## DREAMBUILDER 10/LOT 5 SANCTUARY REDLINES

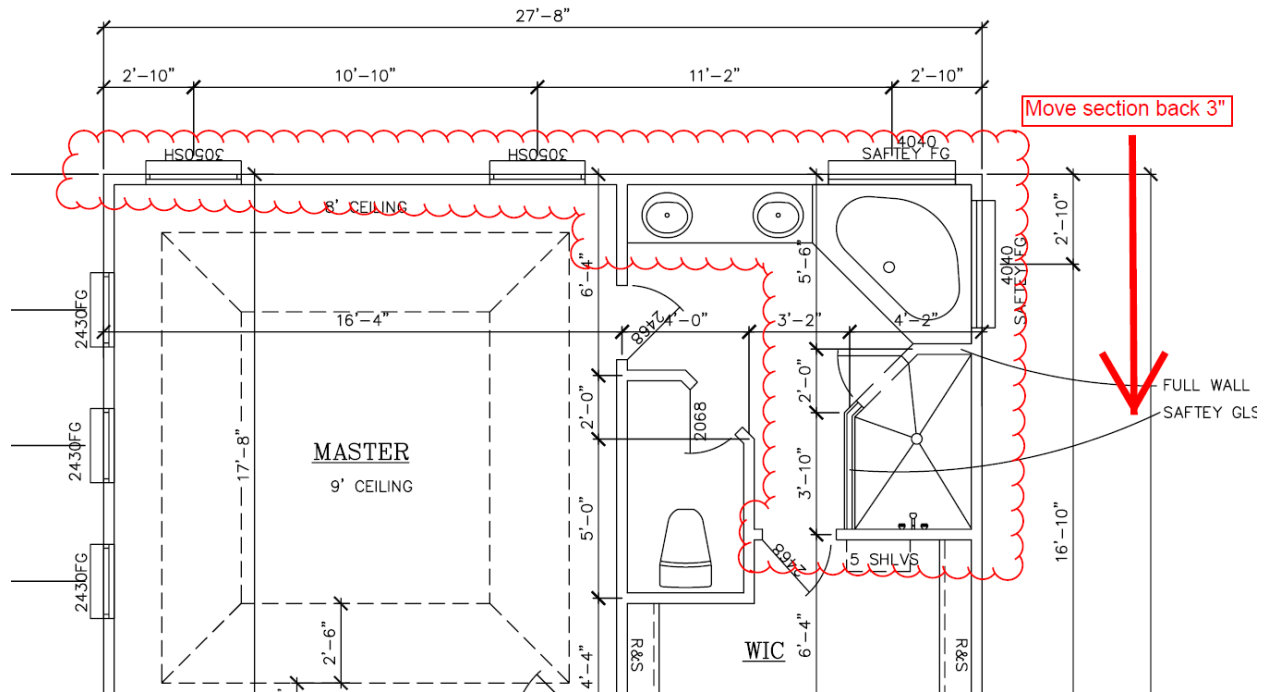
- 1) 8/12/11: Due to an error in the truss layout/engineering, the following section should be moved back 3", making the depth of the second floor 45'5" instead of 45'8". Measurements should be pulled from the front of the house to ensure accuracy.
